BEACON PLANNING BOARD
Via Video-Conference
BEACON, NEW YORK 12508
Phone (845) 838-5002 Fax (845) 838-5026

Beacon Views - Conklin Street

Continue public hearing for SEQRA environmental review on applications for Subdivision and Site Plan Approval, "Beacon Views Townhouses" 40 units, Conklin Street, submitted by Beacon Views, LLC

RE: Beacon Views Site Plan and Conservation Subdivision
Conklin Street
Beacon, New York
Tax Parcel ID: 6055-03-331123

FIRE TRUCK MANEUVER 1
SCALE: 1" = 60'

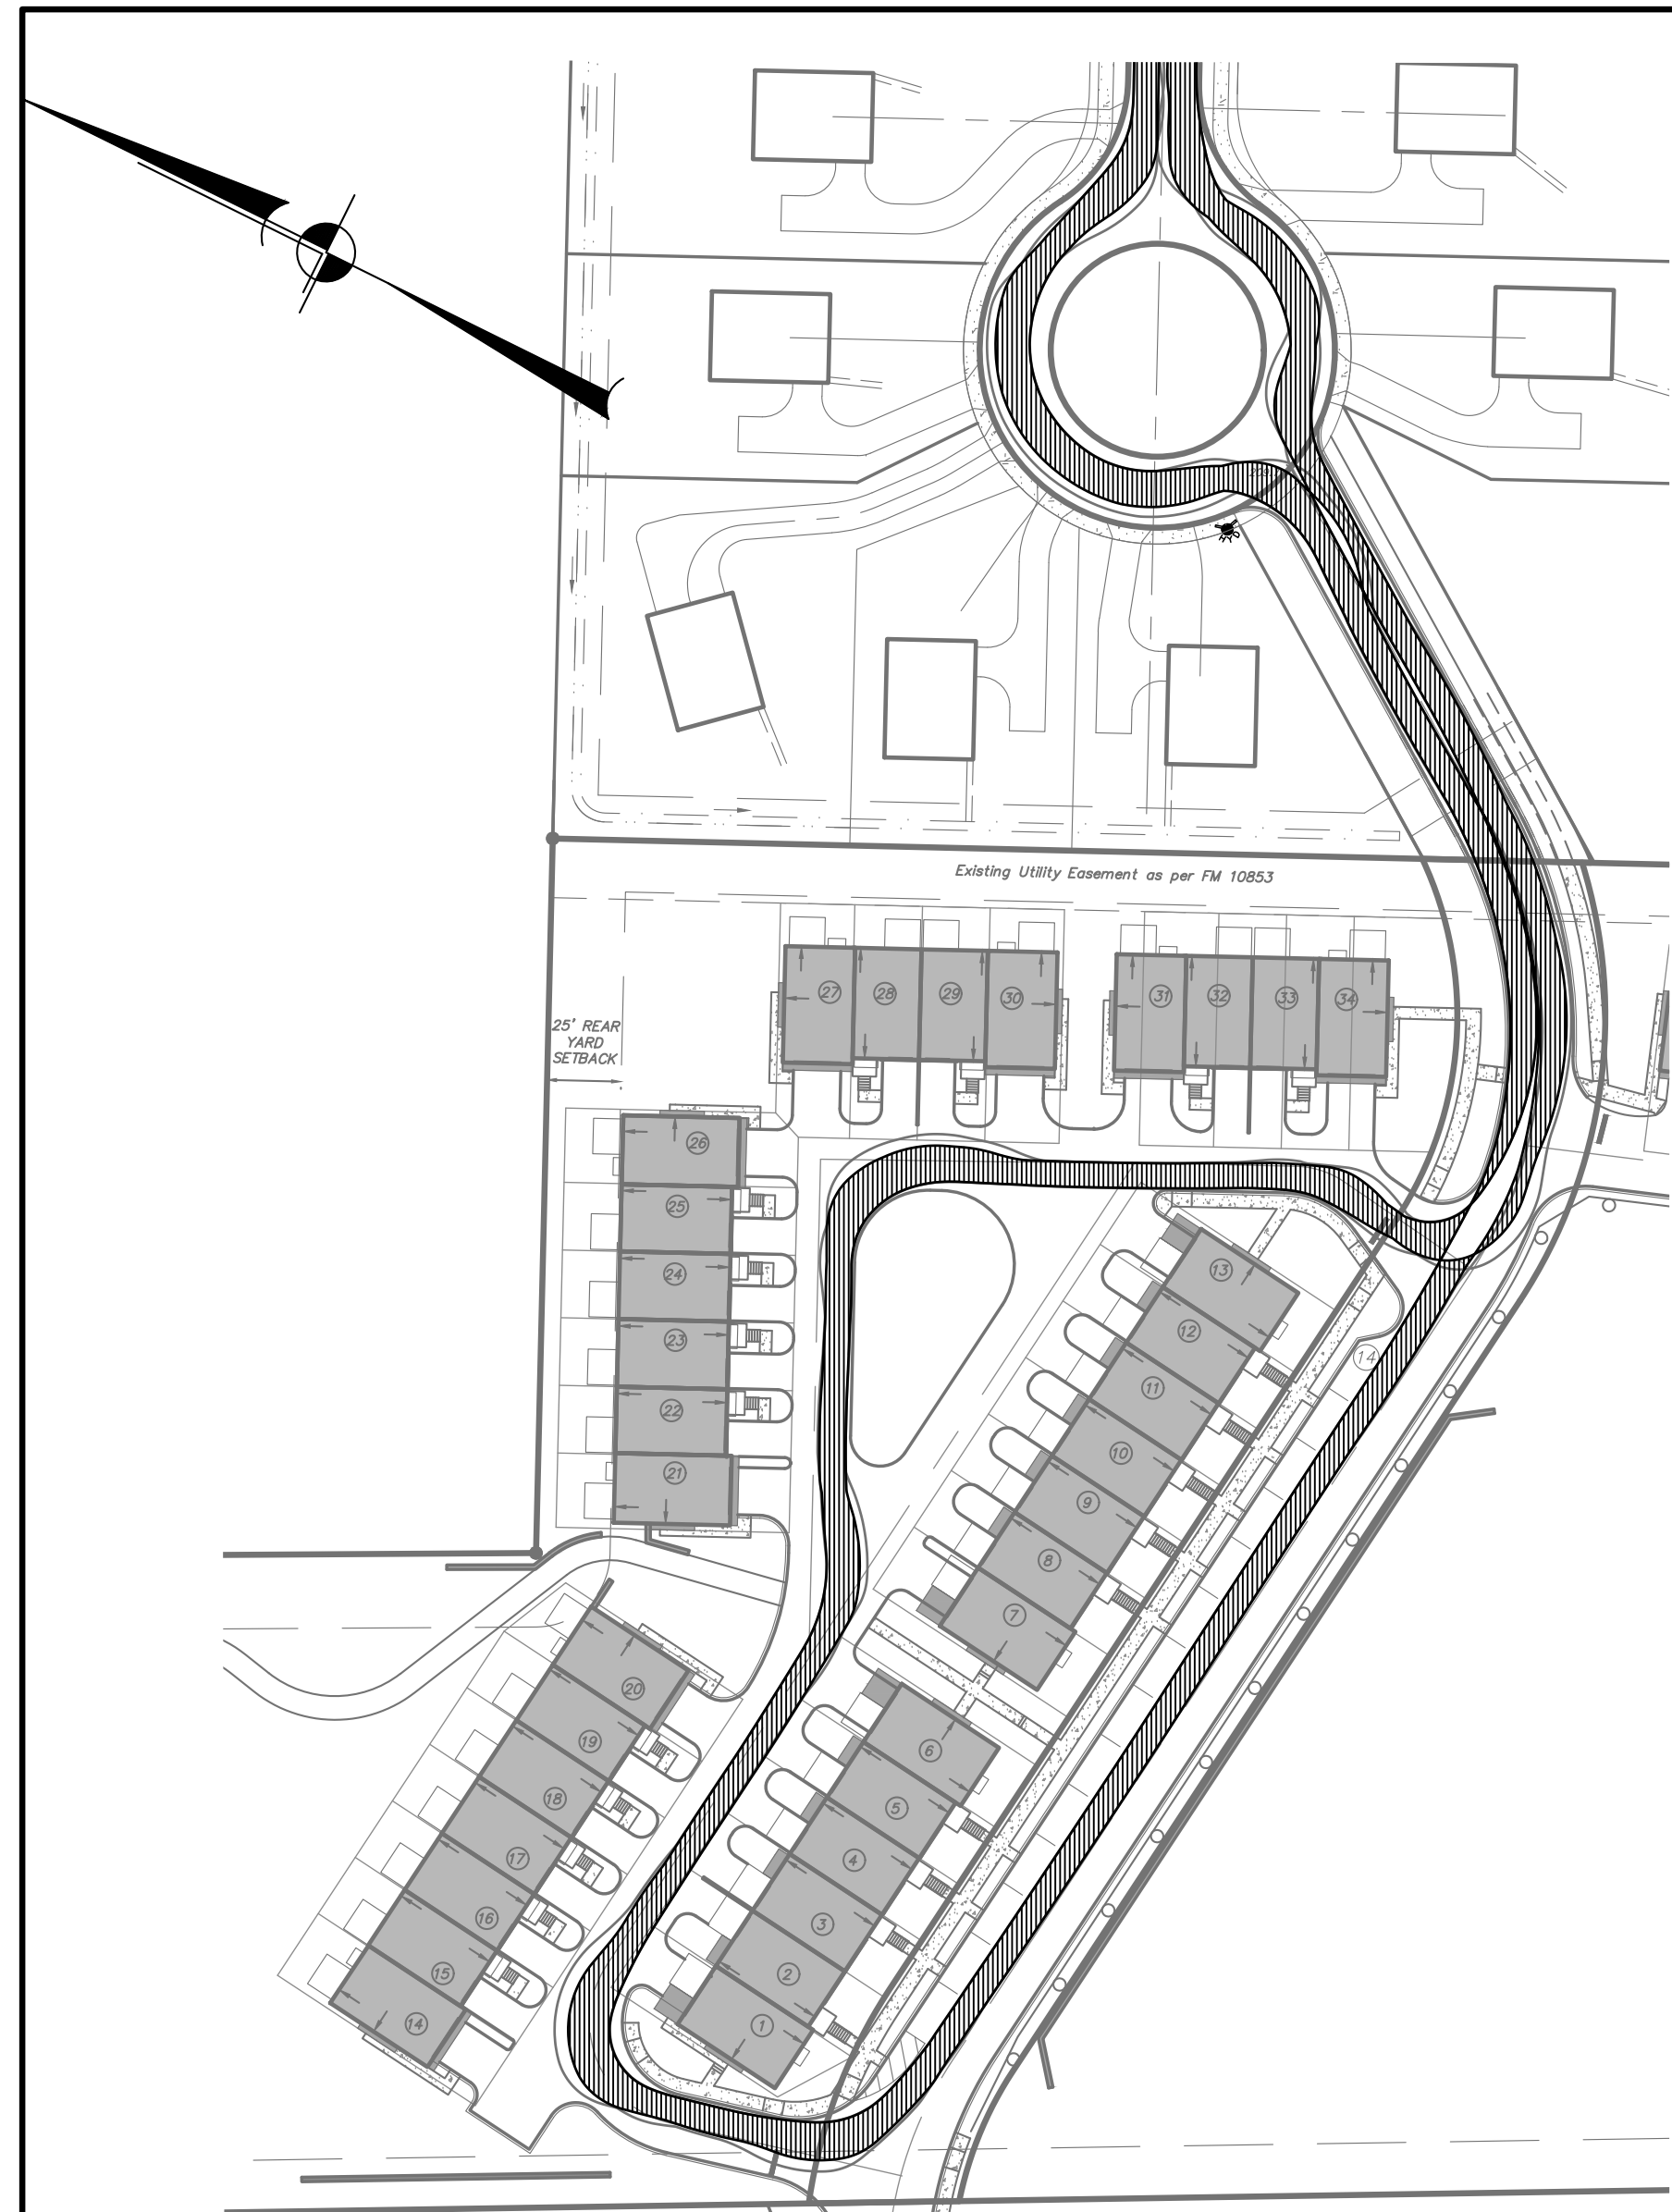
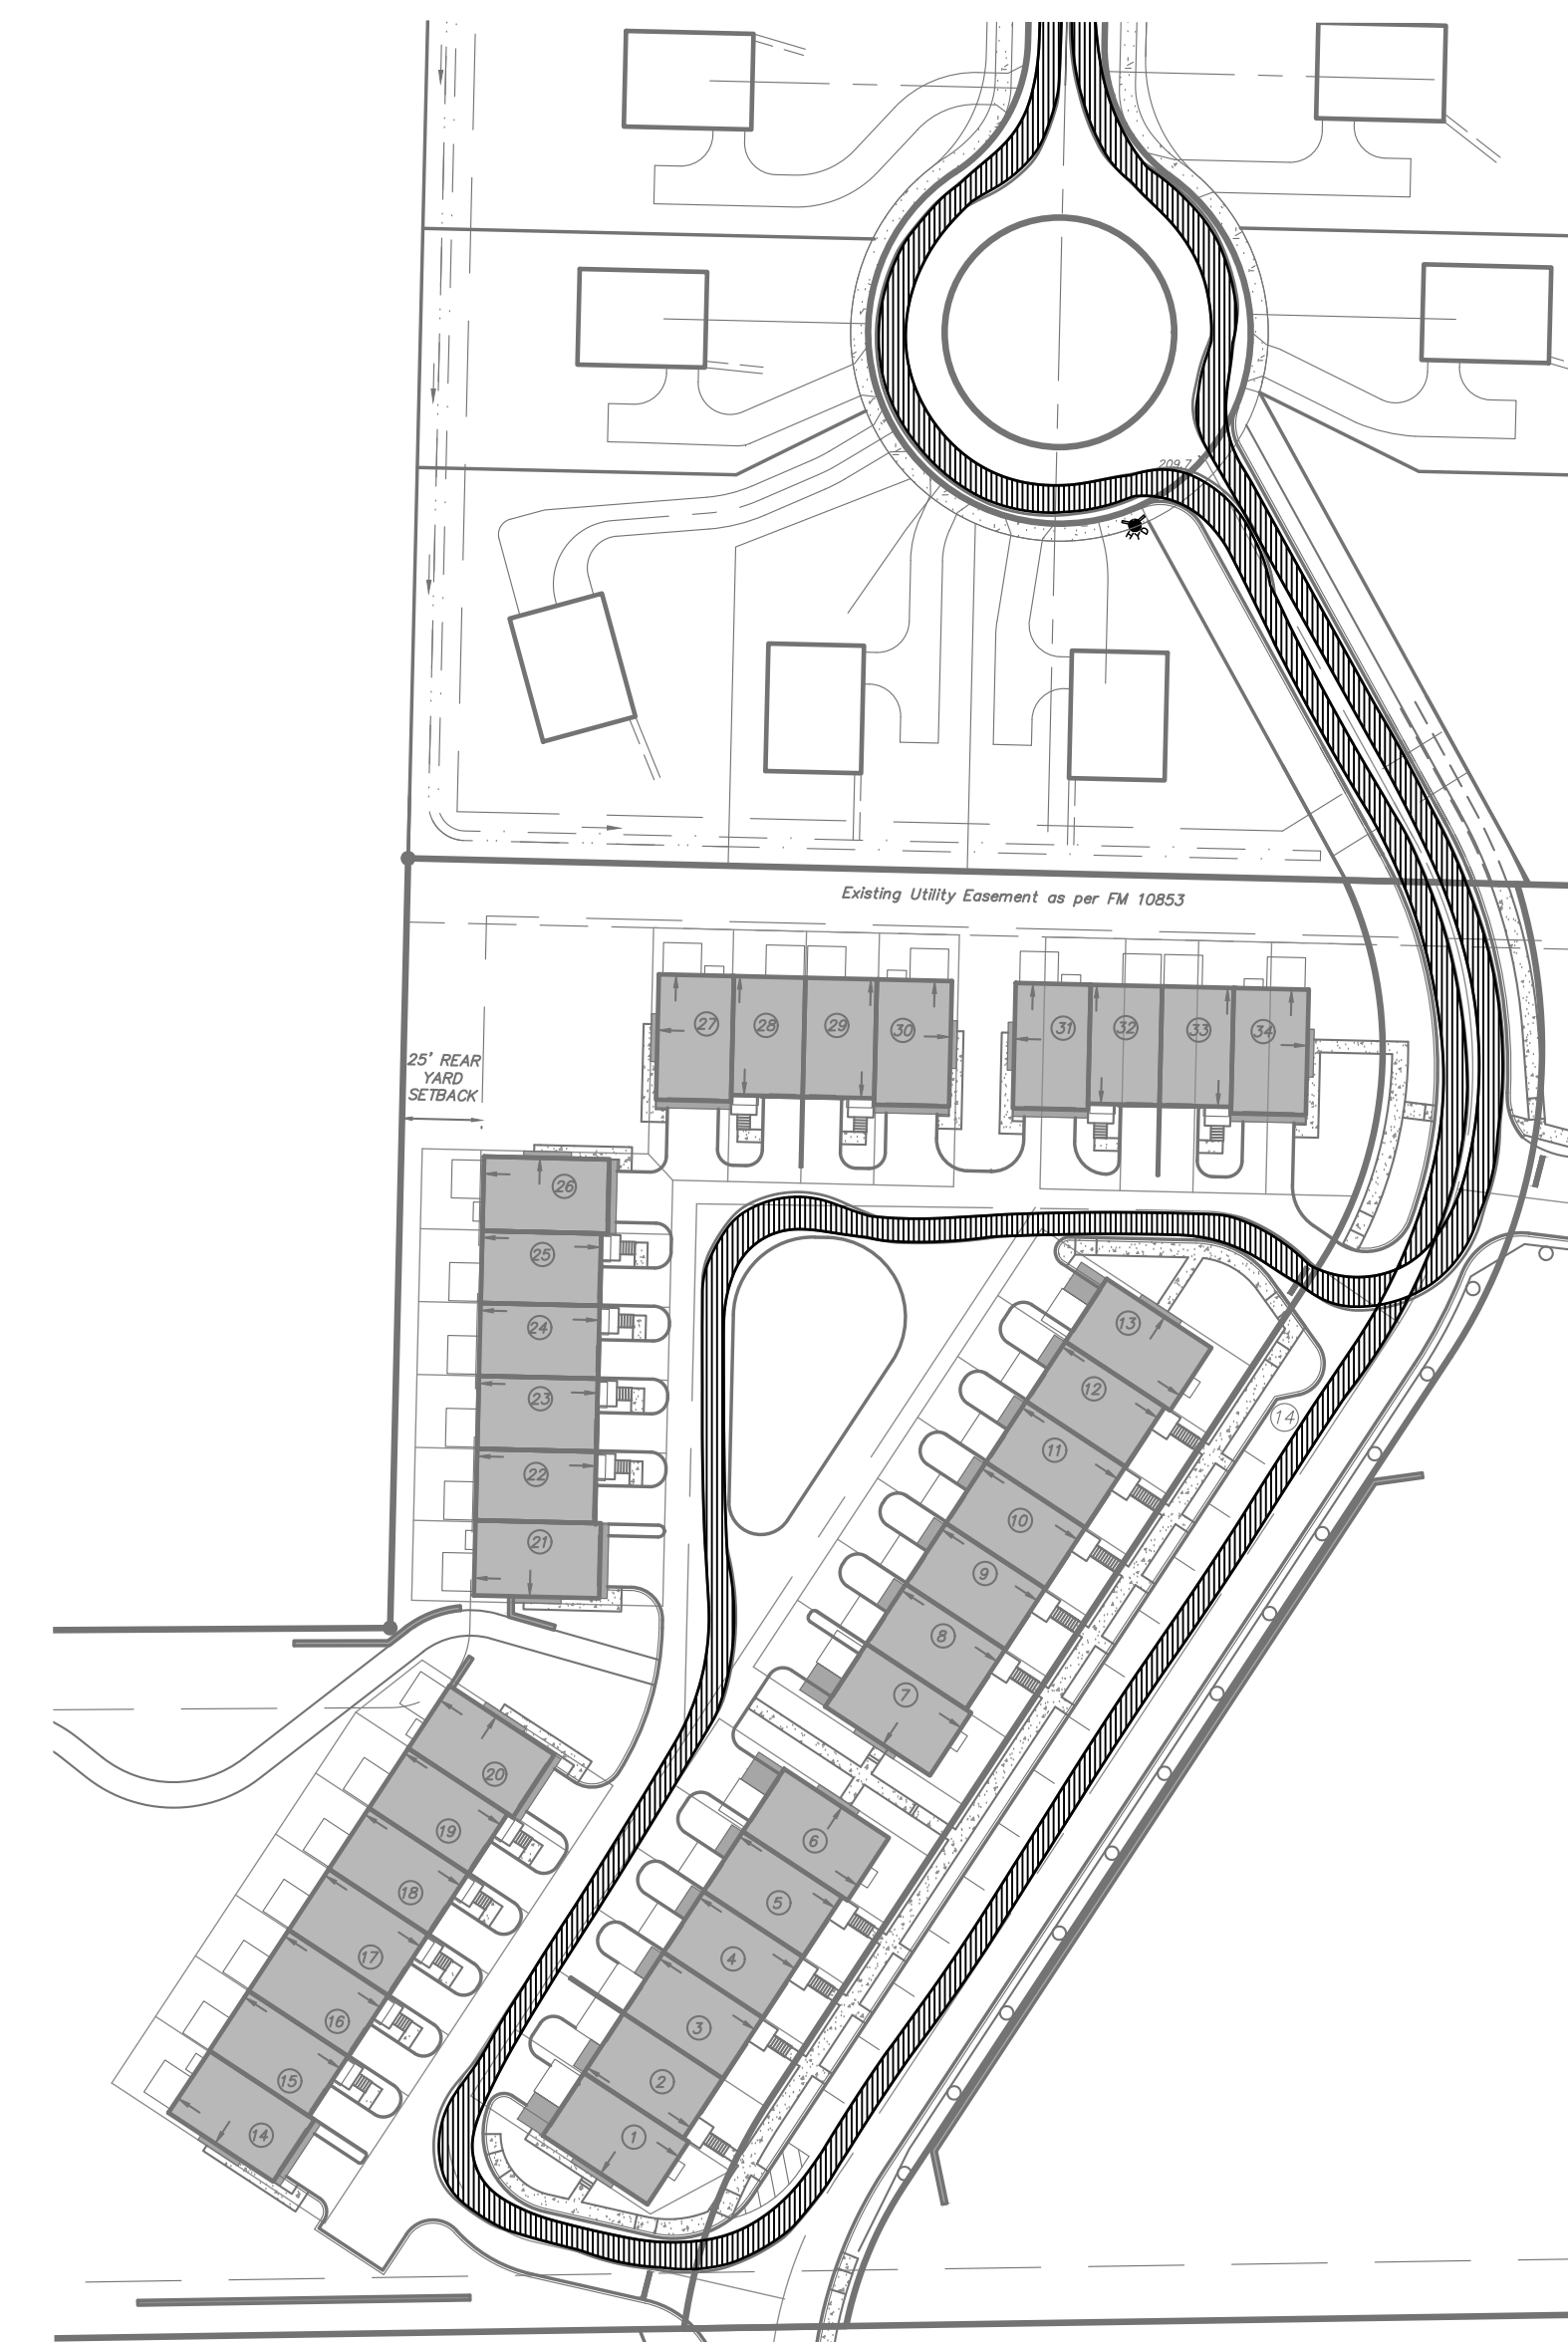
Vehicle Maneuvering Plan (Sheet 8 of 16):

1. The details for the vehicles used should be enlarged so that they are legible.
2. As noted in Comment No. 1 for Sheet 7 of 16 above, the cul-de-sac would need to be modified to provide for a through road in accordance with the City Code. The vehicle maneuvering plans should be revised to reflect this.

1. The additional vehicle maneuvers have been added to the plan as requested. It is the applicant's understanding that provisions for the realignment of the 25 Townsend Street road, including the elimination of the circle, in the event that it was to become a through road, were included and approved with that application.
